Hughes is pleased to announce the release of software version 5.9.5.1 for the Hughes 9502 terminal. The upgrader file name is **9502_Upgrader_5_9_5_1_PC.zip**. This release is a recommended upgrade with several new features and enhancements. The new software upgrader will be available on the Hughes BGAN support page: http://www.bgan.hughes.com

Release Notes for 5.9.5.1 (Since 5.9.4.4)

Figure 1 Yellow highlight indicates where a UT might see both EMEA and MEAS

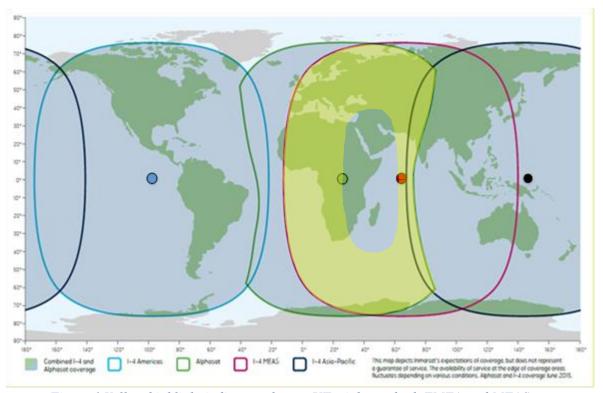
• A Connection field was added to the General Setup page of the Web UI to allow the UT to be configured to operate on a single satellite. With the activation of MEAS some UTs that were using EMEA can now see MEAS as well (see the yellow areas in Fig 1 below). If the UT loses EMEA, e.g. due to an outage during a site switch, it may restart the satellite search and lock onto MEAS. Since the UT is not specifically pointed to MEAS, the signal will be degraded. Depending on how far off bore sight MEAS is, the UT may acquire it but may not be able to operate successfully.

If the UT can see both satellites, i.e. if the azimuth look angle to MEAS is less than 45 degrees from EMEA, it is recommended to reconfigure the UT to only use EMEA. The yellow areas in the figure below show potential areas of concern. For new installs in these areas configure the UT to use only the best satellite (typically the closest). (Satellite pointing calculators/spreadsheets are available on the web and from Hughes.)
